Interactive comment on “Comparison of mixed layer heights from airborne high spectral resolution lidar, ground-based measurements, and the WRF-Chem model during CalNex and CARES” by A. J. Scarino et al.

A. J. Scarino et al.

Received and published: 12 November 2013

Fig. 1.

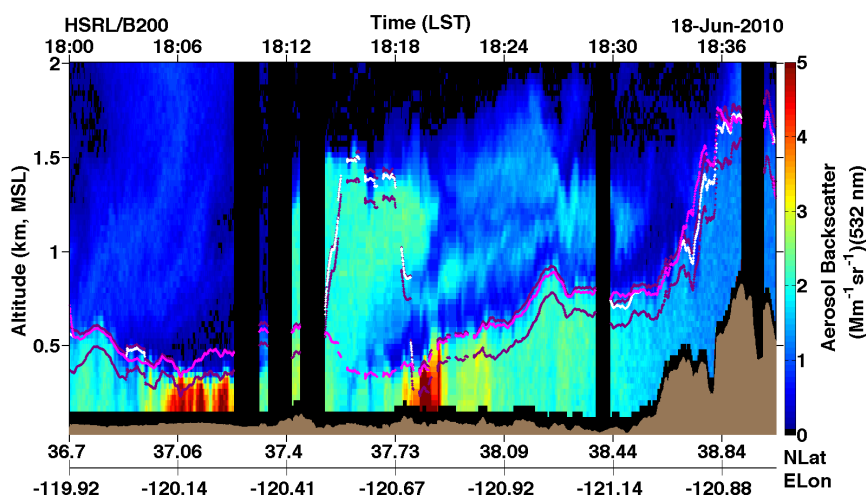
Reviewer: Figures 3 and 4 present lots of areas with no backscatter data (black vertical bars – I presume that represents a lack of data) where the PBL depth has been determined. How was the PBL depth determined in these areas?

Reviewer: Figures 3 and 4 note that they are 1 minute averages. Why? Aren't the PBL depths being determined at 10s time resolution? If they are averages, are they block

Reviewer: What is the altitude used in Figures 3 and 4? Altitude above sea level? Where is the ground?

Response: When the PBL depth was plotted, the dots were connected which is why it looks like there is a PBL depth in those areas. In any updated figures of this type, the PBL depth will be indicated by just dots without the interconnecting lines.

Response: Page 13732, line 14, indicated that the PBL heights plotted are “one-minute running means.” I realize that the caption for Figures 3 and 4 only say “one-minute average.” In the final revision I will use the figure that I have included and the caption will be: HSRL backscatter curtain on 18 June 2010. Deep purple lines show one-minute running average bottom (H1) and top (H2) transition zone heights, and the white line shows the one-minute running average height of the maximum in the wavelet transform of the Haar function. The magenta line shows the “best estimate” ML height. The ground is shaded in brown. The black area between the ground the backscatter data is where the backscatter profiles are limited to 90 m above the ground to avoid contamination from the effects of surface returns.

Response: The altitude is above sea level. A white line indicates the ground in these plots. While it is visible on the digital copy of the paper, it barely shows up when printed. In the revised version, the ground line has been made thicker and the ground has been shaded.
